Re: 176 Scraggy Neck Road, Bourne, MA

I have reviewed the revised site plan (May 16, 2022) and associated documents, and other relevant data and resources published by the Cape Cod Commission, Massachusetts Department of Environmental Protection (MADEP), Massachusetts Coastal Zone Management (MACZM), Massachusetts Geographic Information System (MAGIS), United States Geological Survey (USGS), USDA Natural Resources Conservation Service (NRCS), the Federal Emergency and Management Agency (FEMA) and United States Environmental Protection Agency (USEPA).

Figure 1 - Proposed Septic System and Coastal Banks

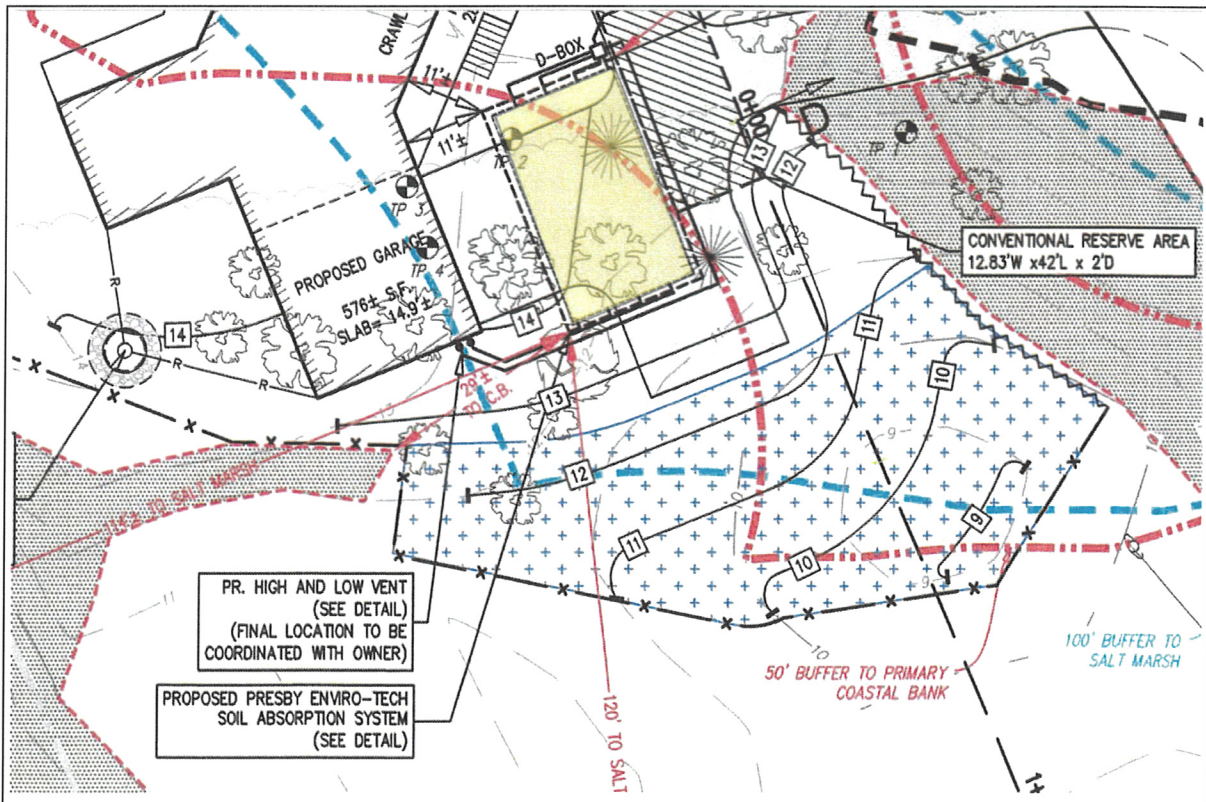
The proposed project shows the septic system 29 feet from the coastal bank (see figure 1). The proposed reserve area is less than 10 feet from the secondary coastal bank.

Figure 2 - Proposed Project and Minimum Septic Setbacks

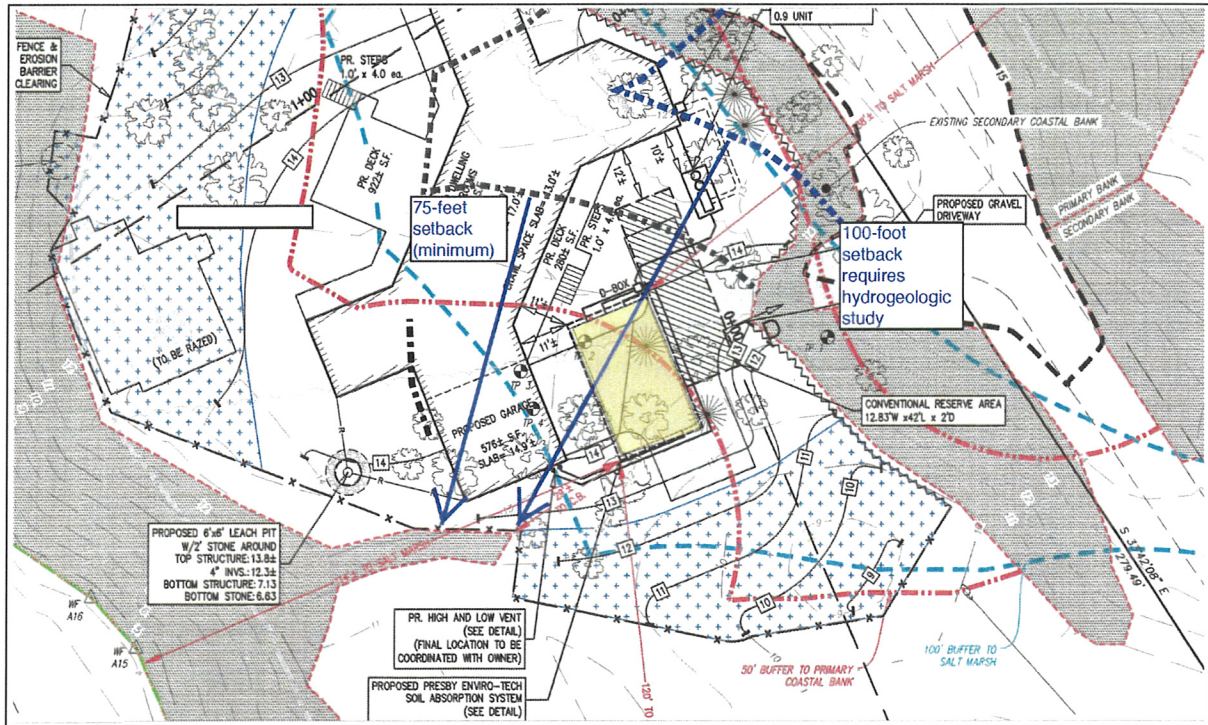
The proposed septic system is within the 100-foot setback that requires a hydrogeologic study (see figure 2). No hydrogeologic study is provided.

3. The applicant is required to complete a hydrogeologic study. As stated above the applicant is required to prepare a hydrogeologic study for any septic system within 100-feet of a coastal bank. This hydrogeologic study should identify groundwater flow directions and groundwater drainage areas to the surrounding salt ponds. The hydrogeologic study should also include revised nitrogen loading calculations based upon the site hydrology and only include recharge as dilution within the delineated groundwater drainage area where the septic system is proposed.
